#### HISTORIC AND DESIGN REVIEW COMMISSION

**HDRC CASE NO:** 2020-049

**ADDRESS:** 210 ADAMS ST

**TYPE OF WORK:** Porch railing modifications

PHOTO DATED 1978
PROVIDED BY APPLICANT

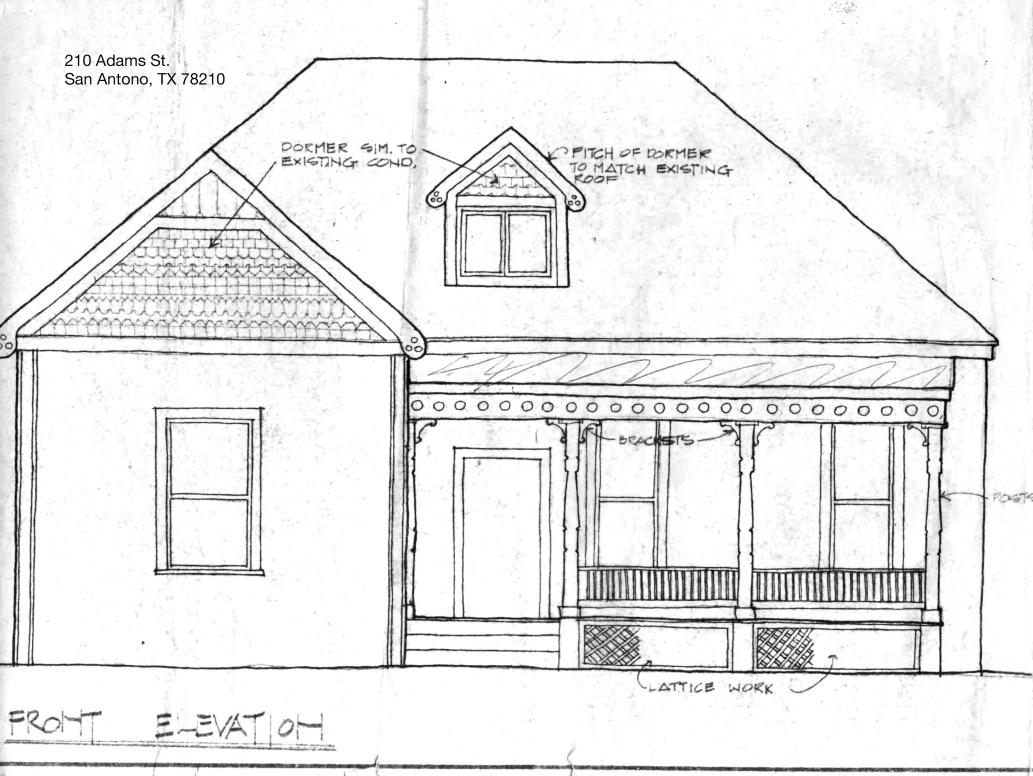
- b. PORCH MODIFICATIONS The applicant has requested to replace the existing turned balustrades with new straight balustrades to match the photo provided, dated 1978. The existing balustrades feature an ornate, turned design. According to the Historic Design Guidelines, existing front porch elements should be preserved, replaced in kind, or restored to their original condition with photograph or similar evidence. Though the porch may have featured straight balustrades in 1978, the photo does not indicate the original configuration of the structure and likely reflects a period after alterations had occurred to the original design. The existing balustrades are compatible with the Folk Victorian style of the structure. Staff does not find the straight balustrades consistent with the Guidelines as proposed, but finds that a more simplified turned balustrade design may be appropriate to be more in keeping with the Folk Victorian style of the historic structure.

Staff does not recommend approval of the straight balustrade design as proposed. Staff finds that a change may be appropriate, but recommends that the new balustrades feature a simplified turned design in lieu of the proposed straight balustrades as noted in finding b.
